SERVICE INSTRUCTION M20-80
DATE 8-15-87

SUBJECT: TS10-360-GB, -LB & -MB ENGINES - TURBO-CHARGER CHECK VALVE CLAMPS INSPECTION.

service bulletin

SUBJECT: TURBOCHARGER CHECK VALVE CLAMPS

FIGURE 1

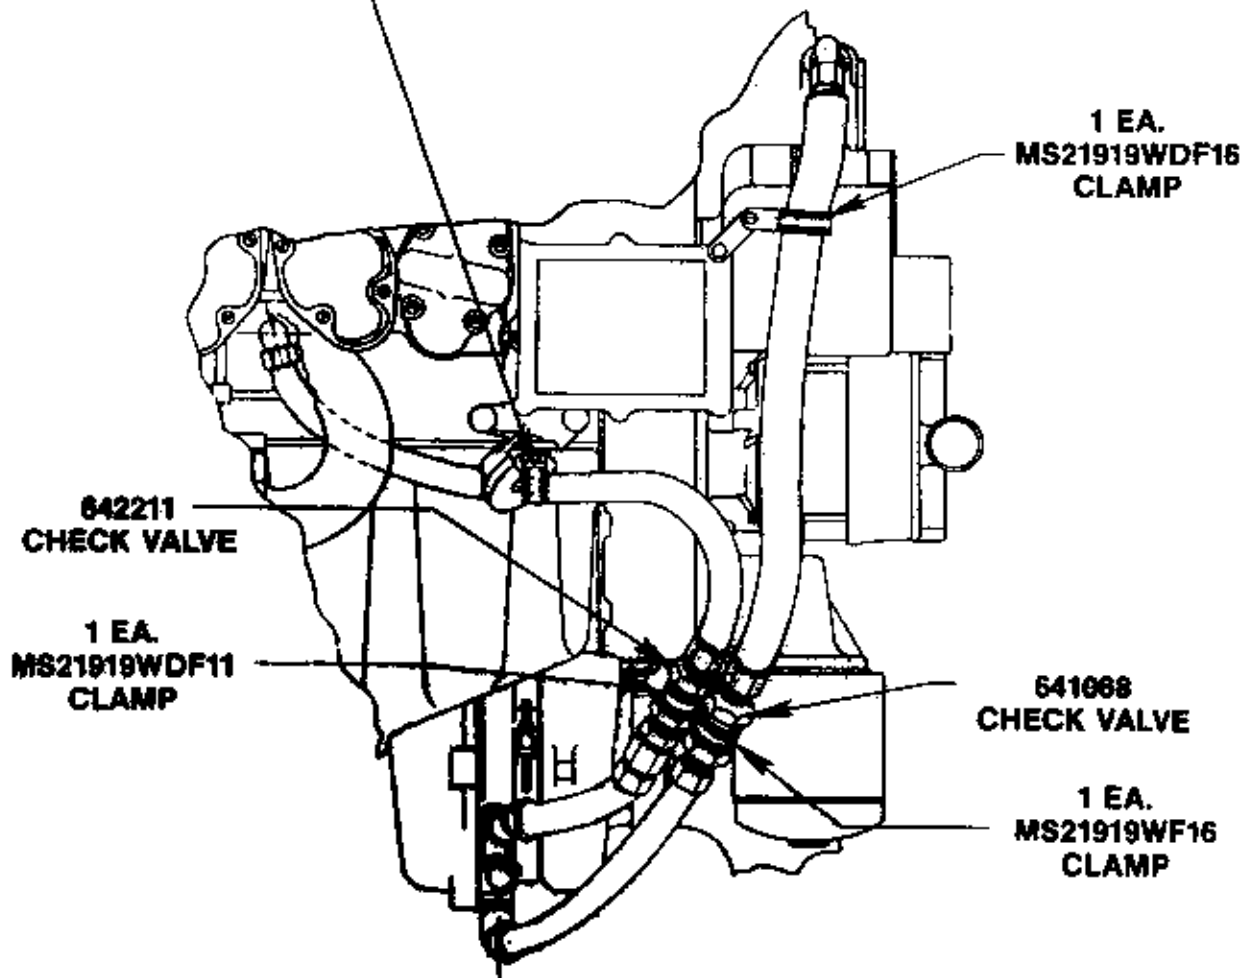
The new clamp part numbers are shown in Figure 1. (A total of three clamps.) These new clamps incorporate a cushion that is yellow in color; the clamps being replaced have a cushion that is black in color.

NOTE: This clamp does not require change.

It is, therefore, required that these clamps be replaced with the current part number clamp. Inspect the check valves and hose for evidence of chafing. If present, the valve(s) or hose must also be replaced.

Installation of these clamps and routing of the hoses must be done in such a manner as to avoid placing the check valves in a bind in the clamp as this could cause a similar wear pattern.
